Reason and overview of the Service Information Letter

The new series of pneumatic clutch installed in AutoGyro Calidus, Cavalon and MTO2017 models, as well as the spare part replacement plate set (46137) are now produced and assembled without wear-limit grooves in the clutch pad.

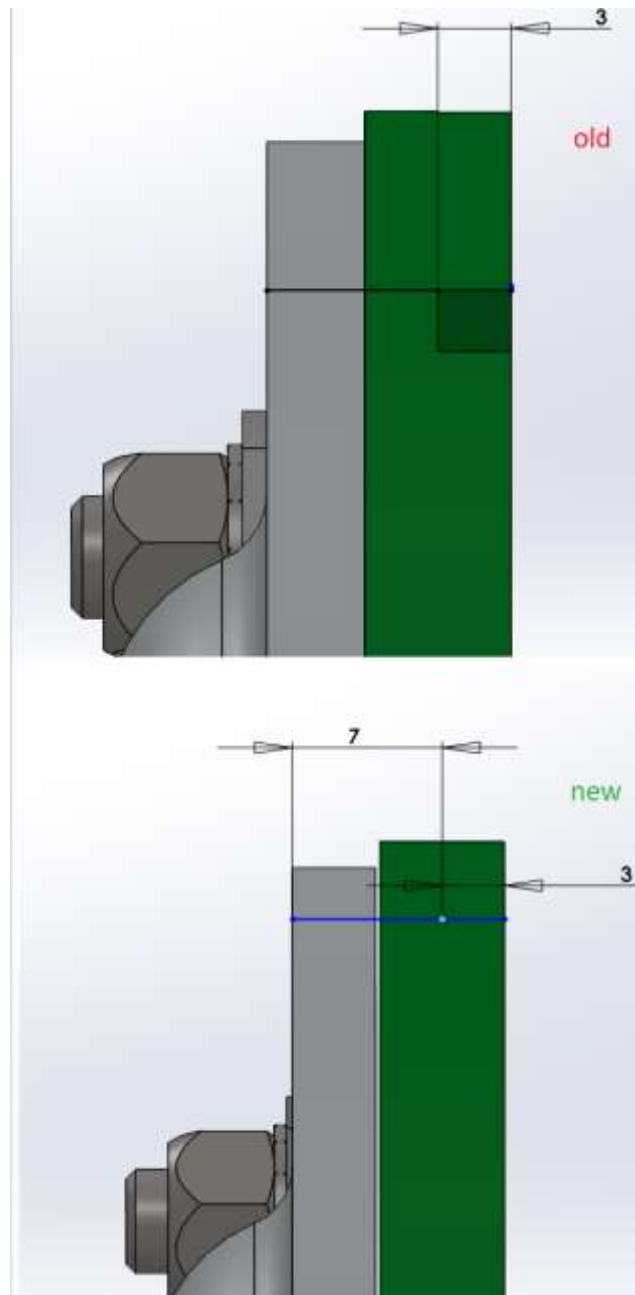
The current inspection method for clutch plate wear stated in job card 63-11-10 6-1 of the respective maintenance manual is therefore no longer valid for clutches incorporating this type of plate. This SIL is the overriding authority in these cases.

The minimum thickness of pad and backing plate as per the diagram below is 7mm, regardless of the presence of wear limit grooves.
